Application for Amendment of Plan Under Section 12A of the Town Planning Ordinance (Cap. 131) to Rezone the Application Site from “Green Belt” and Area shown as ‘Road’ to “Residential (Group C)5” for Proposed Residential Development at Various Lots in D.D. 210 and Adjoining Government Land, Pak Wai, Sai Kung (Planning Application No. Y/SK-HC/8)

Submission of Further Information – Responses to Departmental Comments

Responses-to-Comments Table

Responses to Comments – Departmental Comments

Proposed Mitigation Measure (Solid Fence Wall)

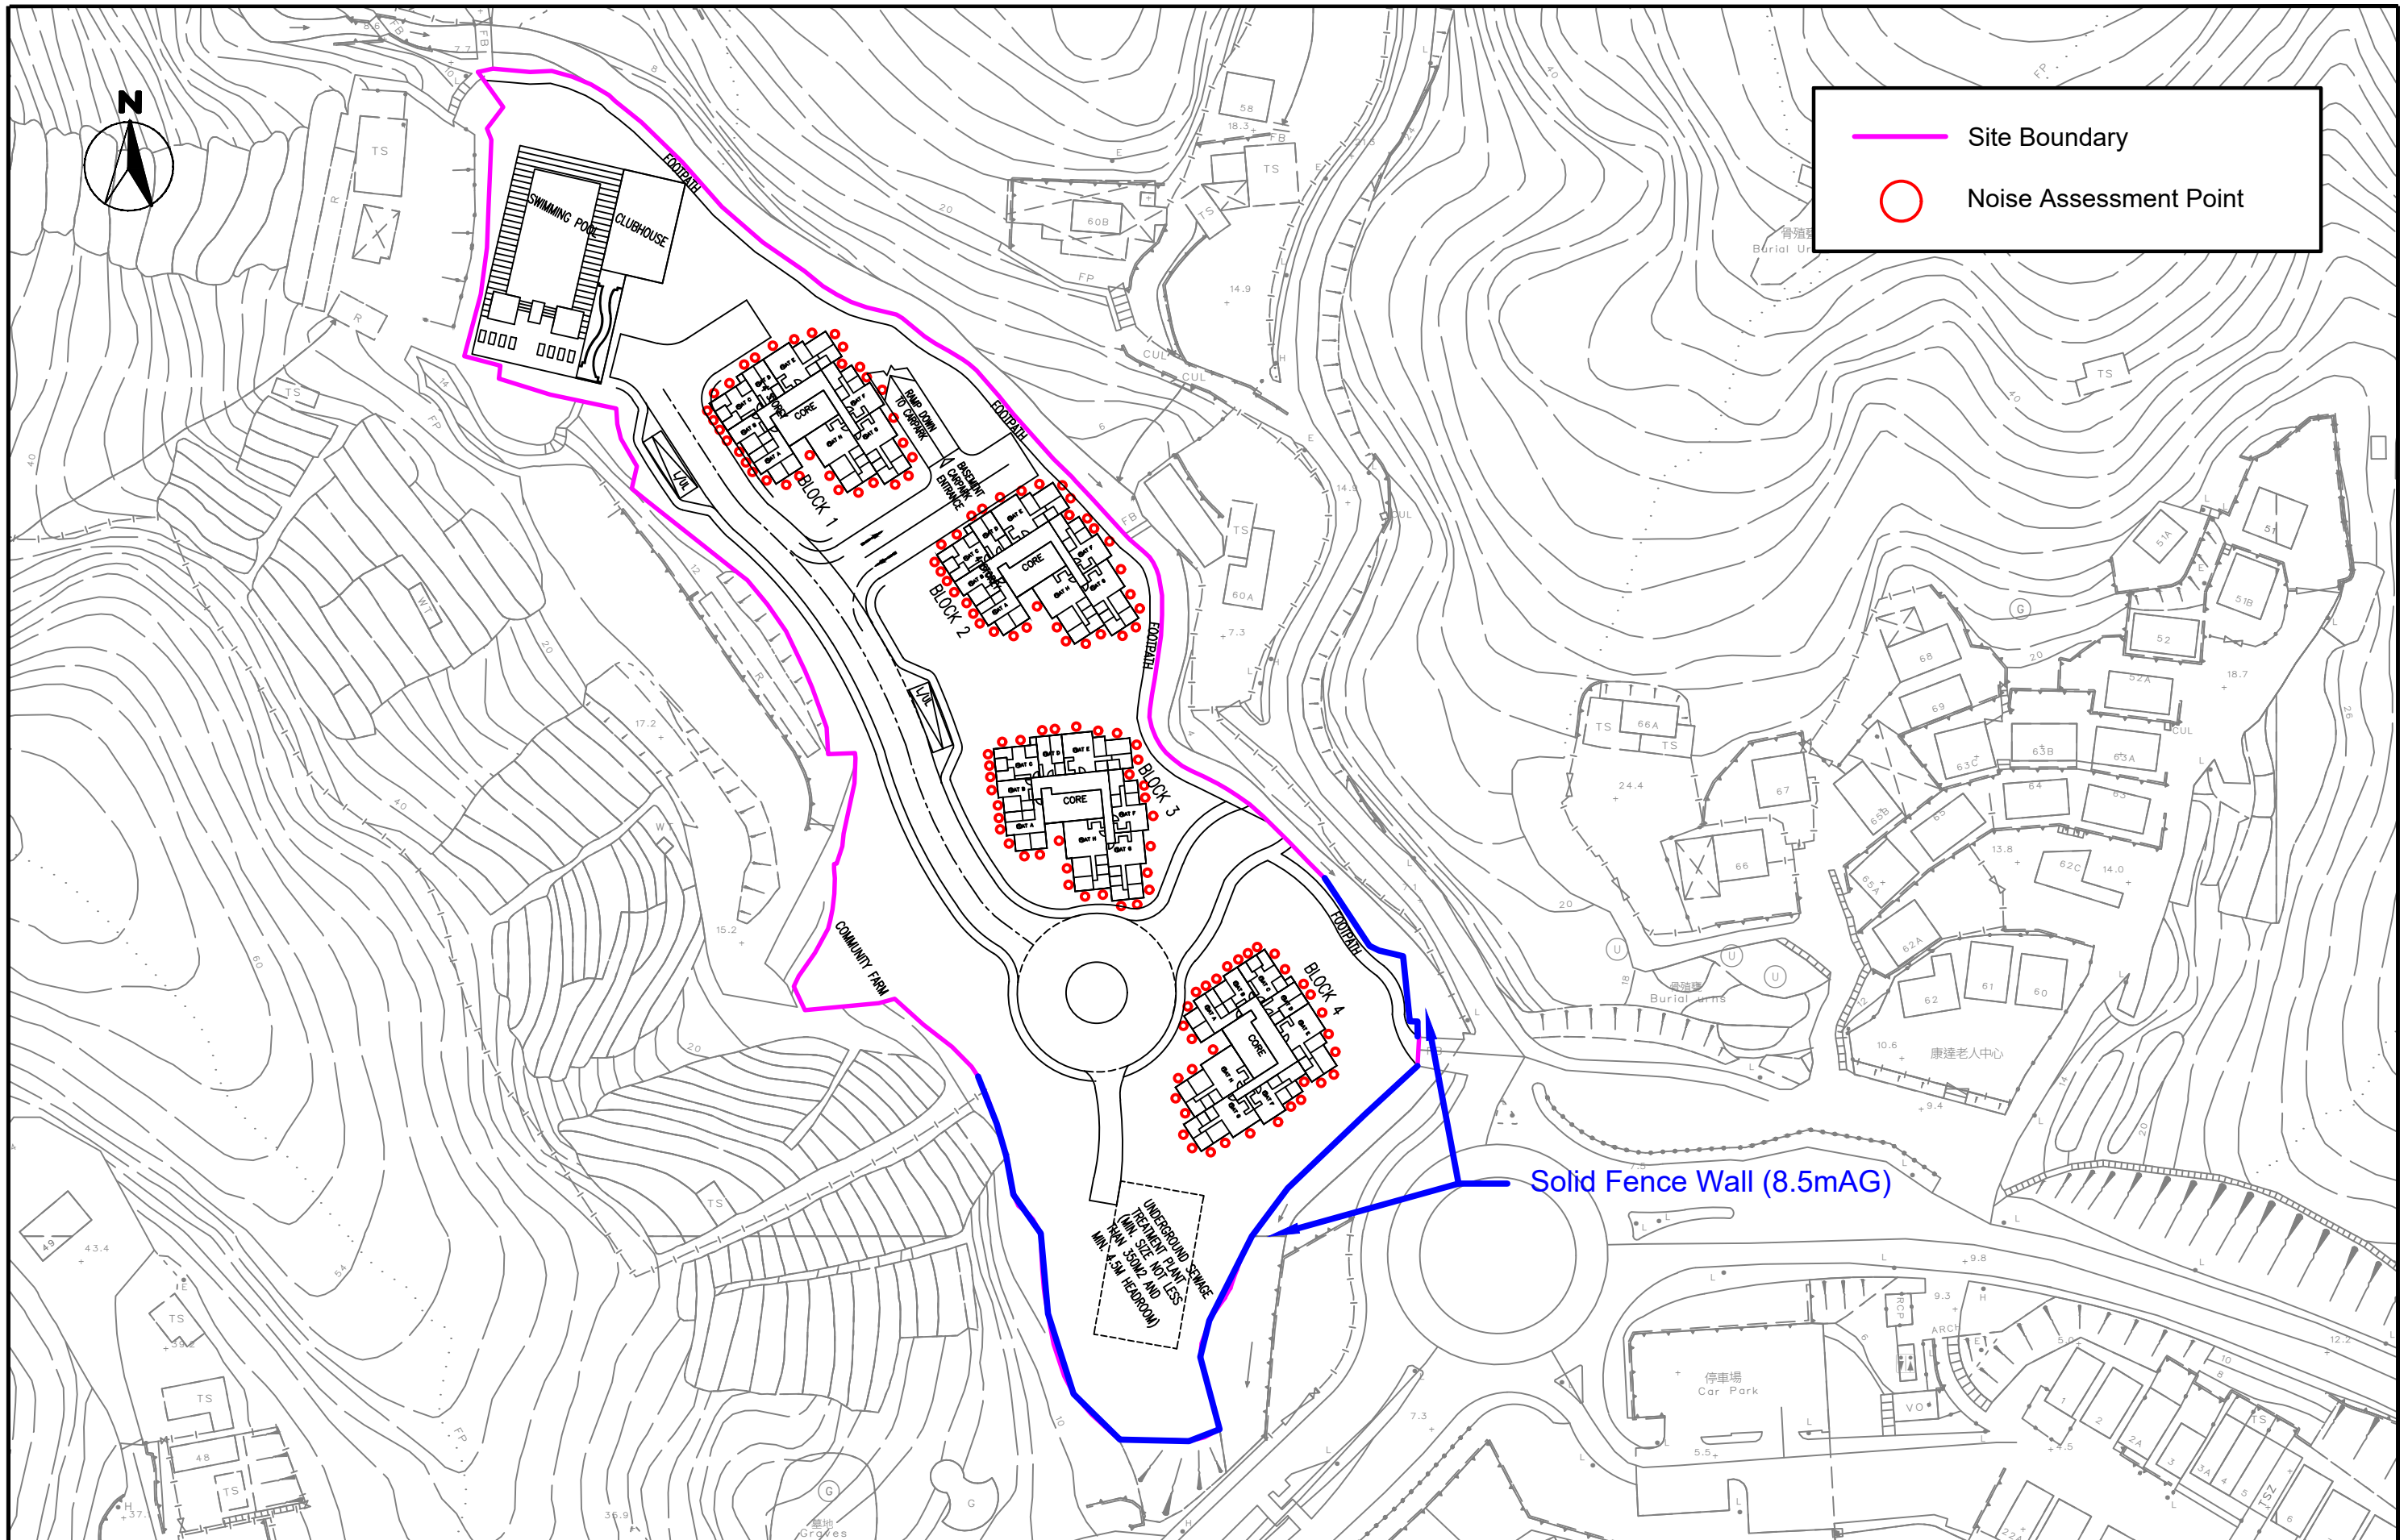
No.	Comments	Responses
	<p>4. Please clarify if the "fence wall" proposed at the southern site boundary is a solid wall. This very tall wall (8.5m above ground) should be considered as noise mitigation measures to mitigate road traffic noise from Hiram's Highway rather than as a given in the base case scenario.</p> <p>5. Table 4-1: Please amend the heading of “Horizontal Distance from Building Facades” as “Horizontal Distance from Nearest Site Boundary to NSRs”</p> <p>6. App.4-2: Please include road speed of the road links in the tables</p>	<p>Sections 4.6.3, 4.6.4, 4.6.7, Figures 4-2a, 4-3 have been revised to clarify the adoption of solid fence wall.</p> <p>The following scenarios have been updated:</p> <ul style="list-style-type: none"> • Base Scenario with solid fence wall (5m above ground) • Mitigated Scenario with taller solid fence wall (8.5m above ground) <p>The fence wall proposed in Base Scenario is 3m taller than the nearby pedestrian walkway as the ground level of the nearby pedestrian walkway is higher. Therefore, the provision of fence wall in Base Scenario is for privacy and safety reason.</p> <p>On the other hand, the taller fence wall is proposed in Mitigated Scenario to protect the NSR from adverse traffic noise.</p> <p>Sections 4.6.3 to 4.6.8, 4.7.3, Tables 4-6, 4-7, Figures 4-2a, 4-3, Appendices 4-3, 4-4 have been revised accordingly under the Revised EA.</p> <p>Noted. The heading of Table 4-4 has been revised as “Horizontal Distance from Nearest Site Boundary to NSRs”. Please refer to Table 4-4 of the Revised EA.</p> <p>Appendix 4-2 under the Revised EA has been revised to include the road speed of the road link.</p>

4.6.7 Since the noise exceedances are identified at Block 4 up to the 3rd floor, a taller solid fence wall with 8.5mAG (14mPD) is proposed, as illustrated in **Figure 4-3**. This mitigation measure is designed to directly shield affected floors from the traffic noise from Hiram’s Highway.
